ADDENDUM - 01

DATE:Monday, 06 March 2023
 FROM:..... Angelo P. Butera, AIA
 VIA: Facsimile

RYEB Project #5672G
 Gloucester City BOE
 INDUSTRIAL ARTS ALTERATION
 NJDOE SP#: 1770-050-XX-XXXX

C-SK-01 STORAGE RACK ANCHOR DTL

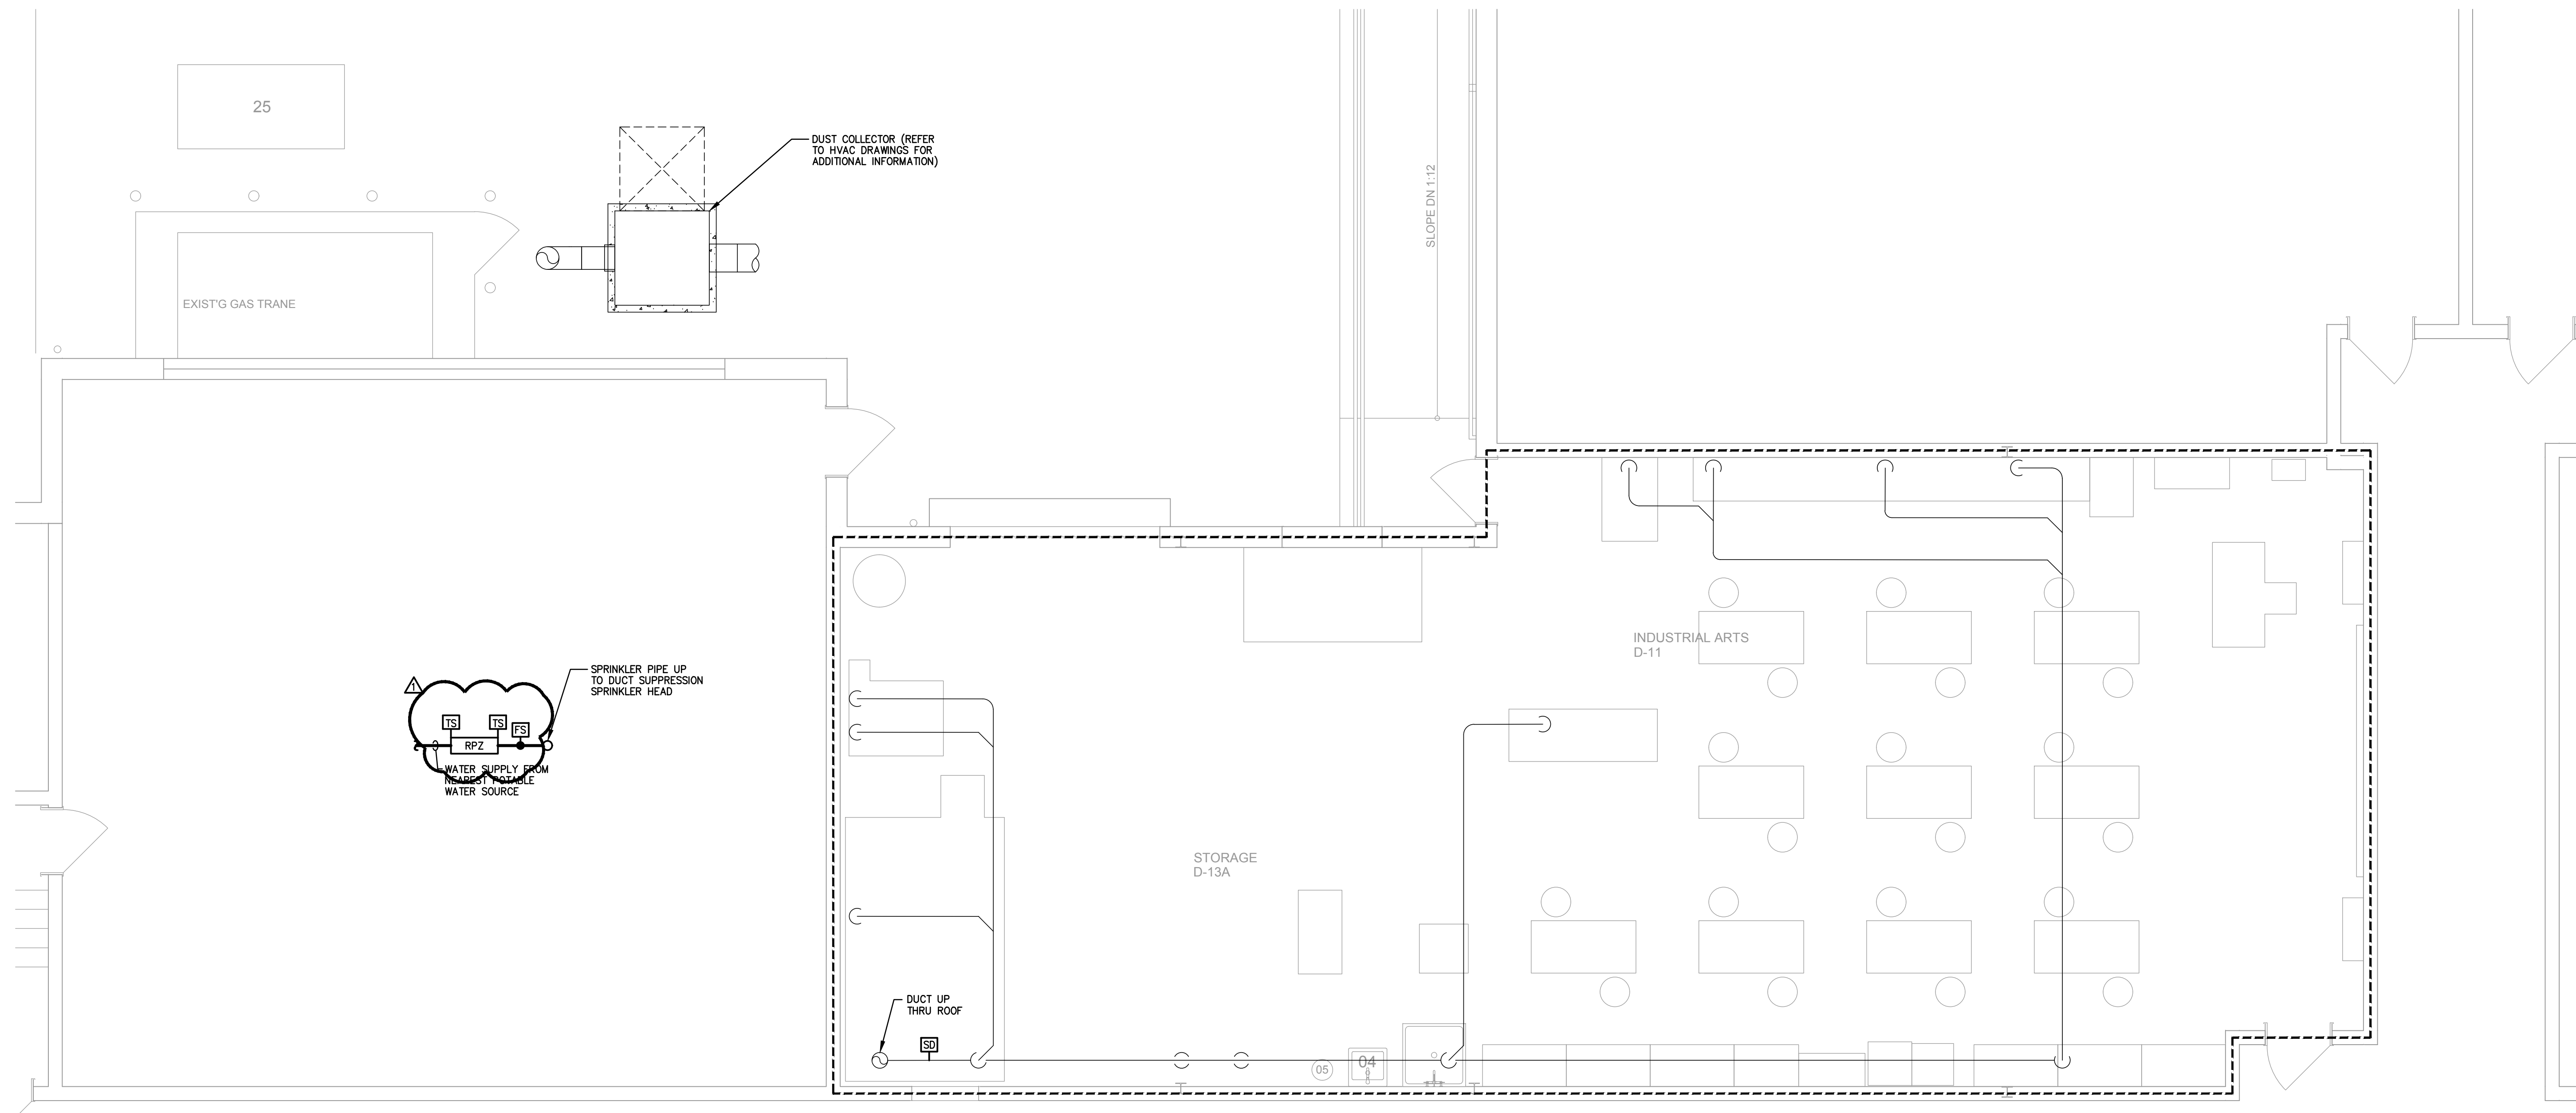
- 1.02. ADD: Attached C-SK-01 Storage Rack Anchor Detail dated 03 Mar 23 to Sht C2.
- 1.03. CLARIFICATION: All proposed chain link fencing shall have “privacy slats” to match existing adjacent fencing.

1 DEMOLITION PLAN - HVAC
 HD100 SCALE 1/4" = 1'-0"

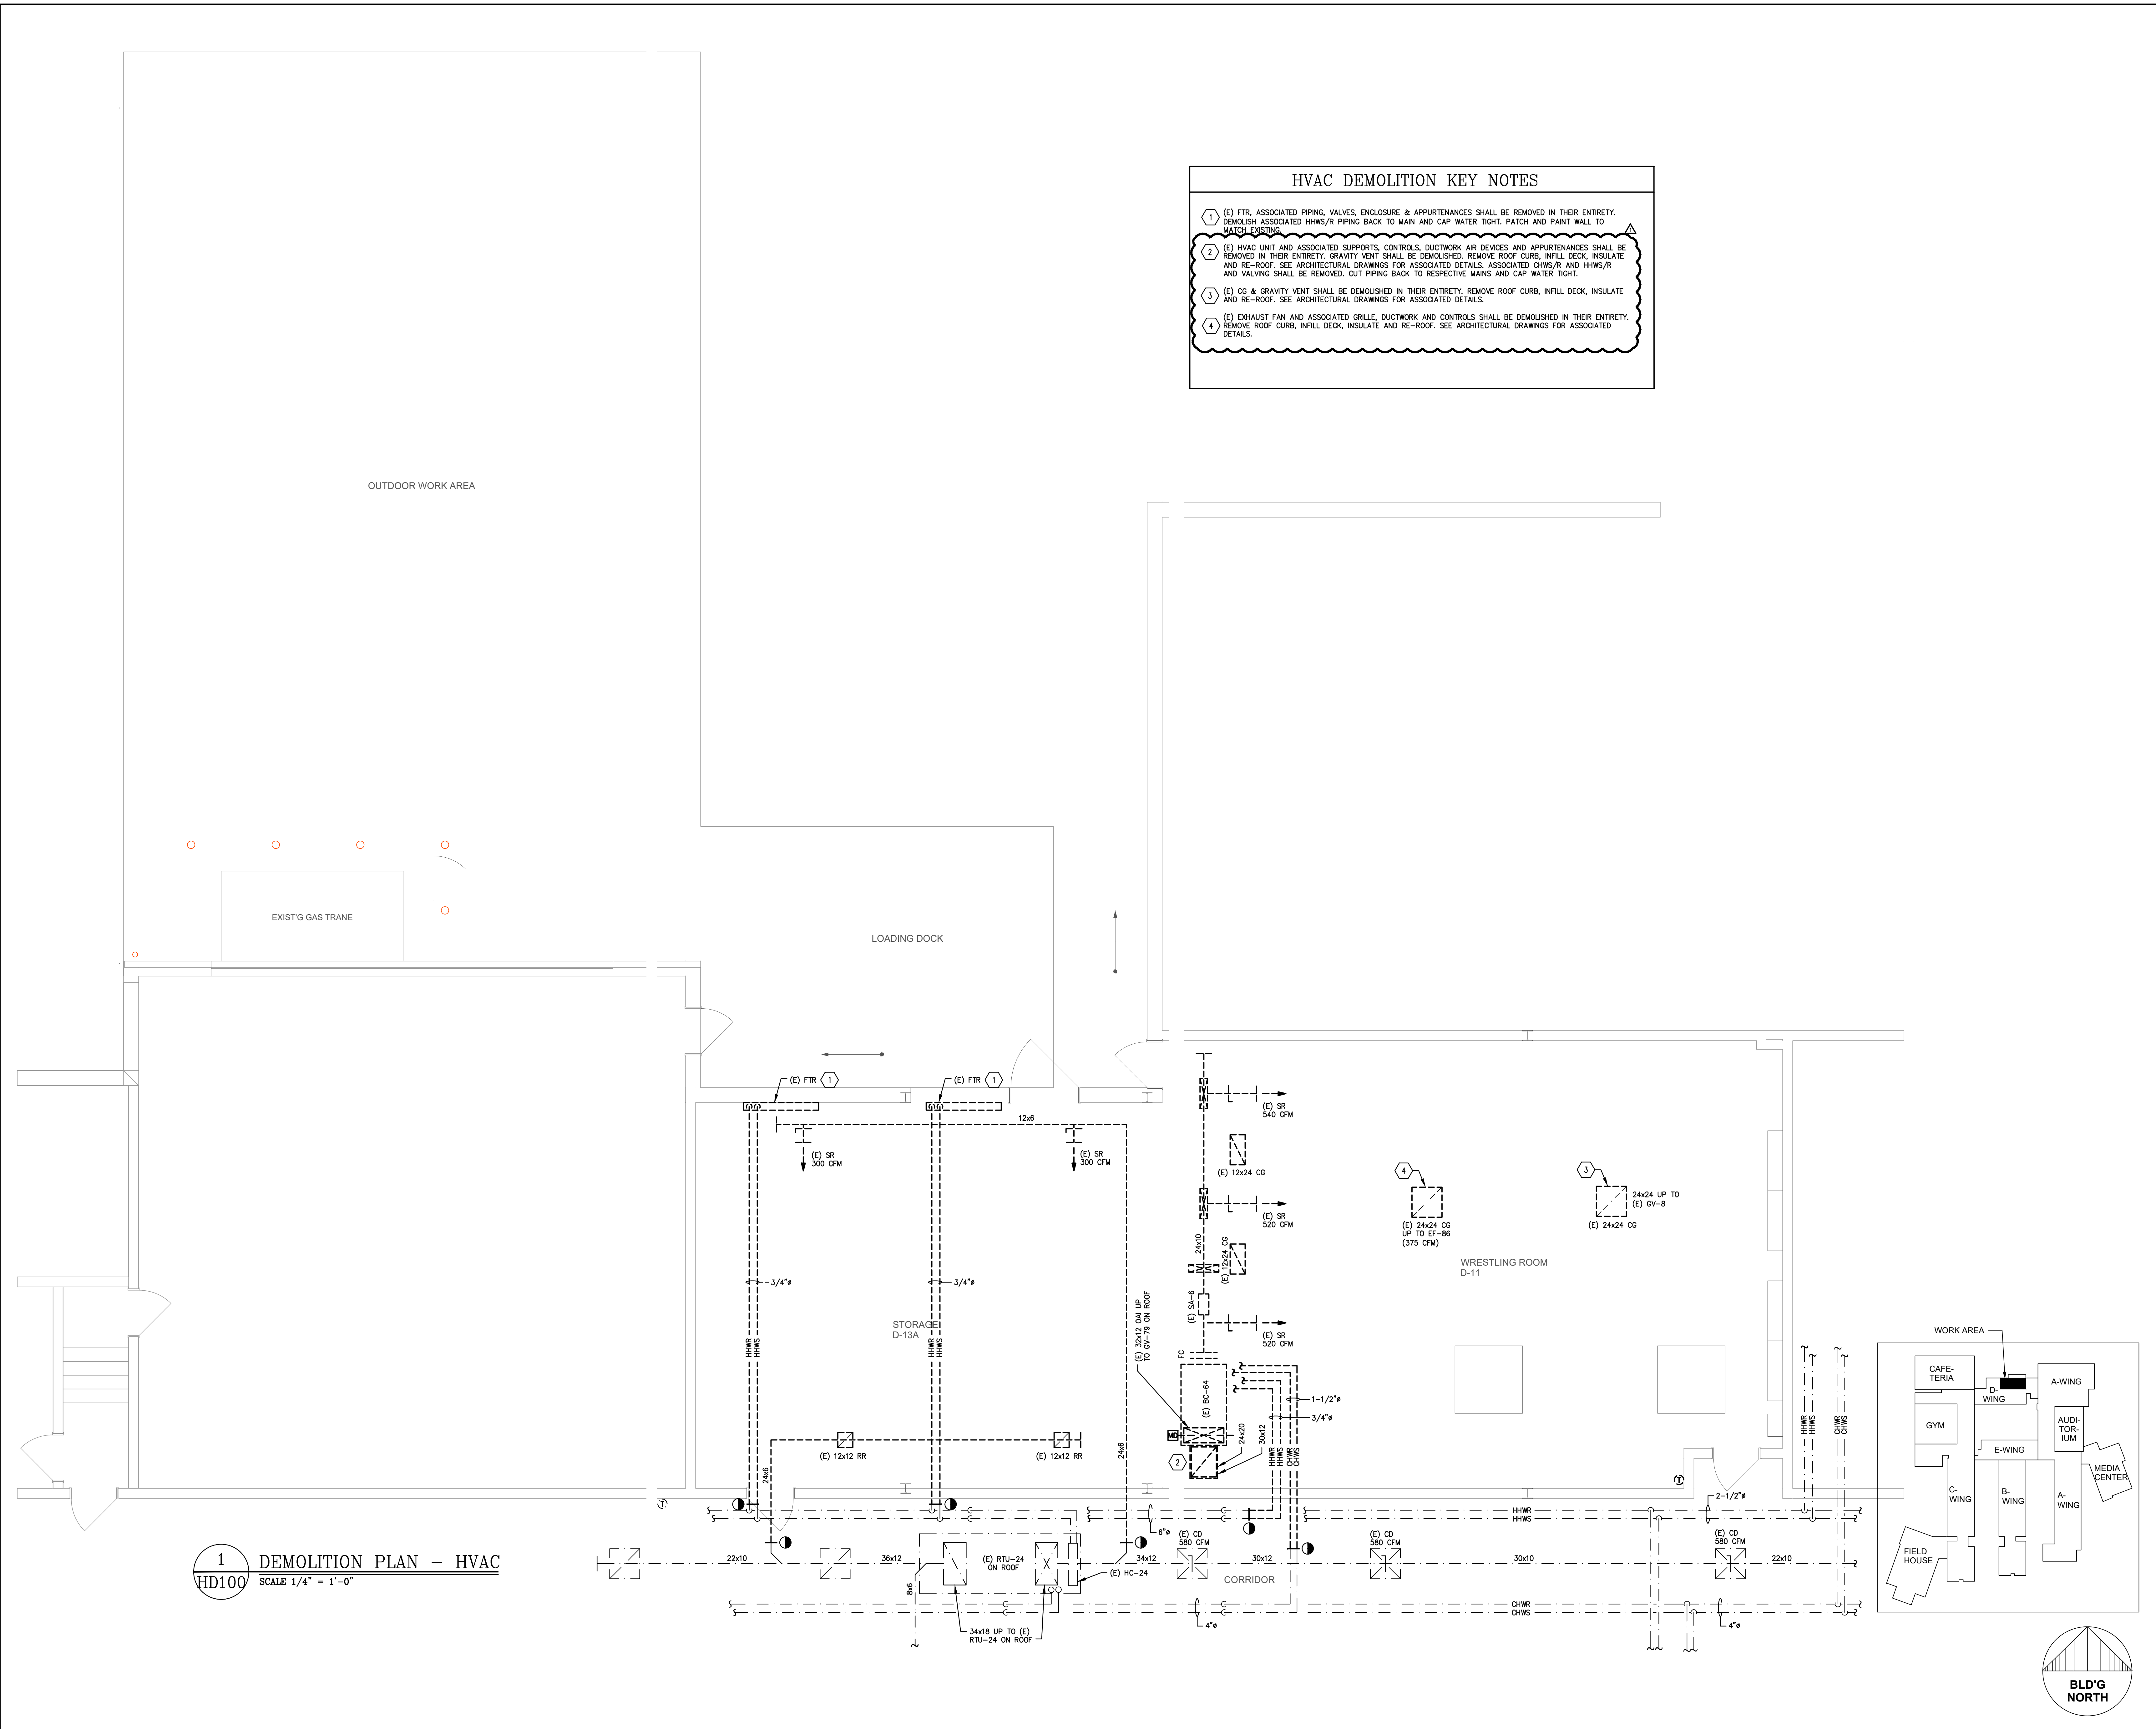
- 1.07. CHANGE: The exist’g HVAC unit BC-64 indicate on Sht HD-100 shall be salvaged by the Contractor & returned to the Owner.
- 1.08. CHANGE: Detail-02/P101 reference to “South Jersey Gas” to “PSE&G”.
